SUBDIVISION REPORT

Final Plat S/D 87-21 - WOOLCOTT FIRST ADDITION

S/D No.: 87-21 Name: WOOLCOTT FIRST ADDITION

Re: Final Plat S/D 87-21 - WOOLCOTT FIRST ADDITION

# WOOLCOTT FIRST ADDITION

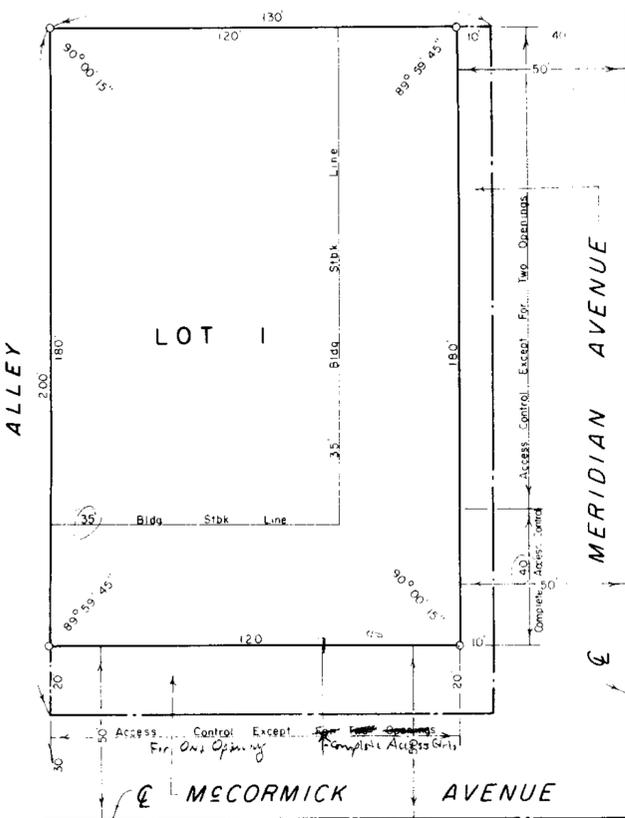
- D. The final plat tracing shall indicate the following access controls to McCormick Avenue:
  1. "Complete access control" to McCormick, from the east 40 feet of the lot.

2. "Access control except for one (1) opening" to McCormick Street from the lots' remaining frontage to McCormick.
- E. On the final plat tracing, the platting text shall be amended to reference that access controls are being granted to the City of Wichita.

- F. Article 7-201(H) of the Subdivision Regulations provides for the dedication of an additional 25 feet of half-street right-of-way back from the intersection of arterial streets. This additional right-of-way is required within 250 feet from the intersection of the centerlines of the arterial streets and tapers back to the normal half-street right-of-way (50 feet) at a point 350 feet from the centerline of the arterial street intersection. Both McCormick and Meridian are classified as arterial streets. Staff has been supportive of not requiring 75 of half street right-of-way at intersections such as this one where development already exists on all four corners. This plat presently depicts the standard 50 of half street right-of-way for both streets which is satisfactory.

C. Forty feet of complete access control shall be depicted to McCormick Street across the east forty feet of the subject lot. The lot's remaining frontage to McCormick Street shall be limited to two access points. The driveway existing within the 40 feet of complete access control may remain open until such time as the McCormick/Meridian intersection is improved. At that time, the driveway will be closed with the project.
